Subject: **SITE PLAN REVIEW: CONDITIONAL USE**-- Swell Brewery – 1802 S Va Dare Trail in the Commercial Zone – Proposed brewery with tasting room, outdoor dining activity Area, 30 parking spaces and associated site improvements

From: Dail, Derek
Sent: Monday, July 13, 2020 4:46 PM
To: Ray, Cameron; Lang, Ryan
Cc: Albright, Steve; Pete Burkhimer (PBurkhimer@american-ea.com)
Subject: FW: Site Plan Technical Review 2 -- Swell Brewery -- 1802 S Va Dare Trail in the Commercial Zone -- Proposed Brewery with Tasting Room, outdoor dining activity area, outdoor waiting activity area and 30 parking spaces

Re: Site Plan Review II
Swell Brewing
2006 S. Croatan Highway (NC 12)

VICINITY MAP
SITE
SUBJECT PARCEL
SHWT 32"
33"
BEACH ACCESS
GRAPHIC SCALE
HICHAEL W. ROBINSON, P.E., P.L.S.
ENGINEERING AND SURVEYING
PRELIMINARY SITE PLAN
SWELL BREWING
BREWERY AND TASTING ROOM
S-1
110717

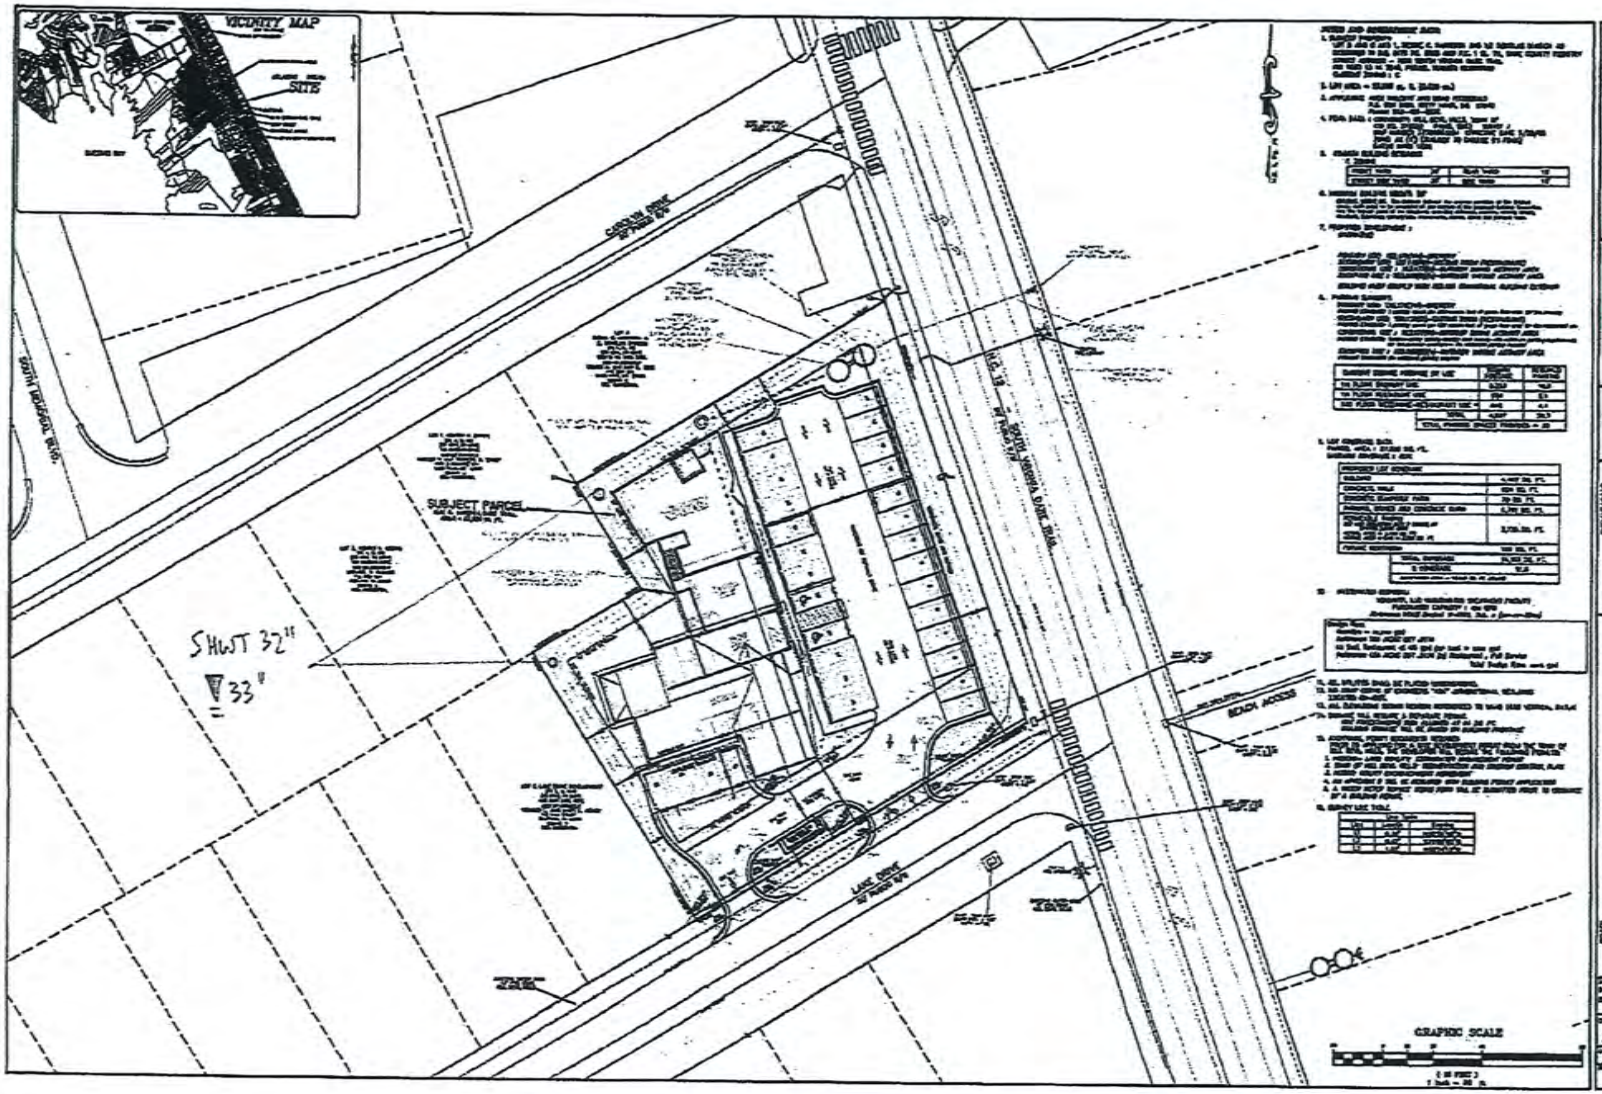
1. Indicate proposed 12" HDPE in E. Lake Drive to be 12" HDPE N-12 Sock Drain.

2. Change the label for the existing WM in Virginia Dare Trail from 8" PVC C900 to 12" PVC C905.

1. The proposed right-of-way drainage is generally acceptable. There is an existing 15" culvert that connects the drop inlet on the northwest corner of Lake Drive and NC 12 to the drop inlet located on the north side of Lake Drive and immediately east of the proposed eastern driveway that needs to be included on the plans. Public Services is working with the engineer to make some minor adjustments to the plan and streamline the drainage in this area.

1. A copy of the NCDEQ Wastewater Extension (Fast Track) permit will need to be provided prior to issuance of a building permit.
2. A copy of the NCDOT encroachment agreement for the wastewater force main will need to be provided prior to the issuance of a building permit.
3. Provide a profile section on the drawings or the wastewater force main and waterline crossing.
